Pennsylvania Power & Light Company

SUSQUEHANNA STEAM ELECTRIC STATION  
NRC INSPECTION REPORT 50-388/84-12  
NOTICE OF DEVIATION  
ER 100508 FILE 841-04  
PLA-2221

### RESPONSE TO NOTICE OF DEVIATION

#### DEVIATION (388/84-12-02)

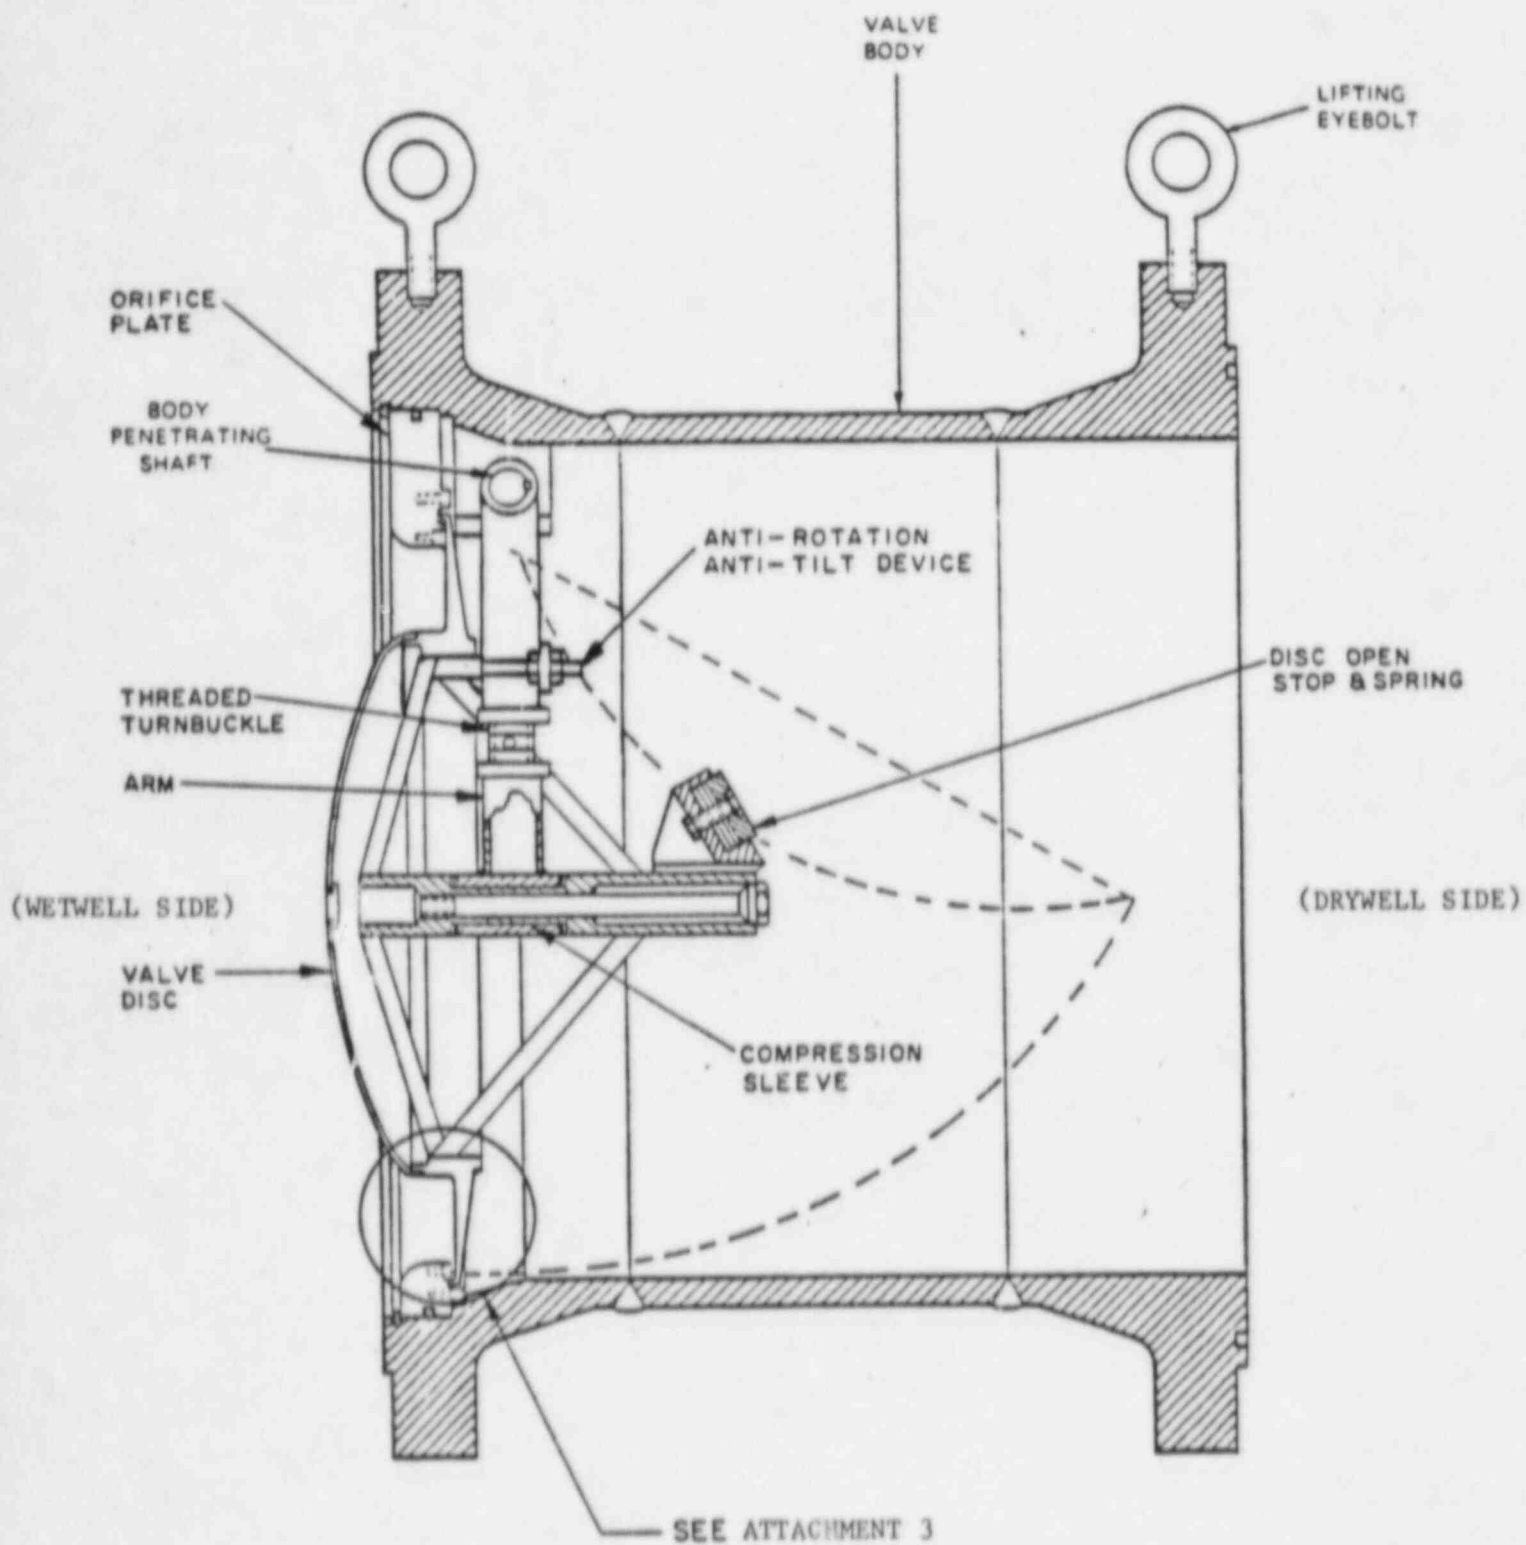
Final Safety Analysis Report (FSAR) Section 6, Paragraph 6.2.1.1.3.2 states that the inboard and outboard suppression pool drywell vacuum breakers will indicate "not fully closed" when the valve disk is 0.32 inches (inboard) and 0.2 inches (outboard) off their seat.

Contrary to the above neither surveillance procedure SO-259-002, Revision 0, nor SM-259-002 Revision 0, used to test the suppression pool drywell vacuum breakers provided any quantitative values or instructions to calibrate or verify settings of the vacuum breaker position indication switches as stated in the FSAR.

The position indicating switches are operated through a mechanical linkage external to the valve body that is connected to the body penetrating shaft (see Attachment 2) which rotates as the valve disk opens or closes. Disk movement is transmitted through the mechanical linkage to the position indicating switches. The switches complete an electrical connection to a remote indicator which provides a visual indication that the valve is closed. When the valve disk reaches the full open position a rotary switch is actuated which provides remote visual indication that the valve is open. Hysteresis exists in the mechanical linkage and the switches. Wherever possible, hysteresis is minimized, but its exact value is not established nor is it constant (due to manufacturing tolerances, mechanical wear, and thermal growth). The position indication switches provide nominal indications of valve disk position (open or closed) above the hysteresis tolerance.

Susquehanna is not in deviation with the FSAR since the values provided in the FSAR are for design information and do not constitute calibration criteria. In addition, for the reasons presented above, precise position indication for each vacuum breaker is unnecessary.
